Access Compliance Report

Public Rights-of-Way

(Curb Ramps)

Intersection ID: 45543	Main Street: GOSHAWK_LN	Cross Street: ROOK_RD	Location: E
ADA ID: 03682BA22E35	Ramp Type: Perp	Initial Pass/Fail: Pass	Overall Compliance: No
Severity Score: 0.25			
Codes/Mitigation Info/Possible Solution		Field Measurements/Component Compliance

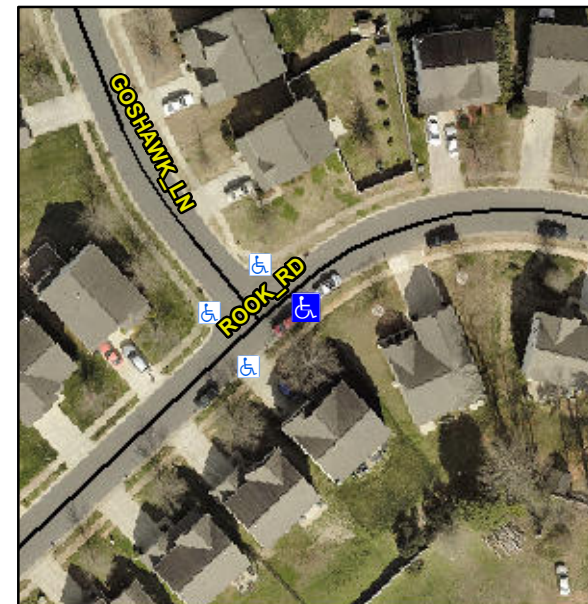
Not Found, R304.5.3, R304.2.2-Perp, R304.3.2-Para, R305.2

Compliance	Description	Data	Compliance	Description	Data
N/A	Ramp Length (in)	49.0	Yes	Ramp Slope (%)	6.8
Yes	Ramp Width (in)	48.5	No	Ramp XSlope (%)	3.8
N/A	Flare Type LT	Sloped	N/A	Flare Type RT	N/A
N/A	Flare Slope LT (%)	5.5	Yes	Flare Slope RT (%)	7.2
N/A	Flare Traversable LT?	Yes	N/A	Flare Traversable RT?	Yes
Yes	Landing Length (in)	48.5	Yes	DWS Provided?	Yes
Yes	Landing Width (in)	48.0	Yes	DWS Contrast?	Yes
No	Landing Slope (%)	3.0	Yes	DWS Length (in)	24.5
Yes	Landing X Slope (%)	0.8	Yes	DWS Full Width?	Yes
N/A	Landing Curb? (Y/N)	No	No	DWS Offset (in)	4.5
N/A	Shared Landing?	No			
Yes	Gutter Ponding?	No	Yes	Gutter Slope (%)	4.0
Yes	Gutter Lip Ht (in)	0.0	Yes	Gutter X Slope (%)	0.7
N/A	Painted X Walk1?	No	N/A	Painted X Walk2?	N/A
	X Walk 1 Direction	To NW		X Walk 2 Direction	N/A
N/A	X Walk 1 Width (in)	N/A	N/A	X Walk 2 Width (in)	N/A
	X Walk 1 Slope (%)	0.8		X Walk 2 Slope (%)	N/A
	X Walk 1 X Slope (%)	1.8		X Walk 2 X Slope (%)	N/A

Remove & Replace Entire Ramp.
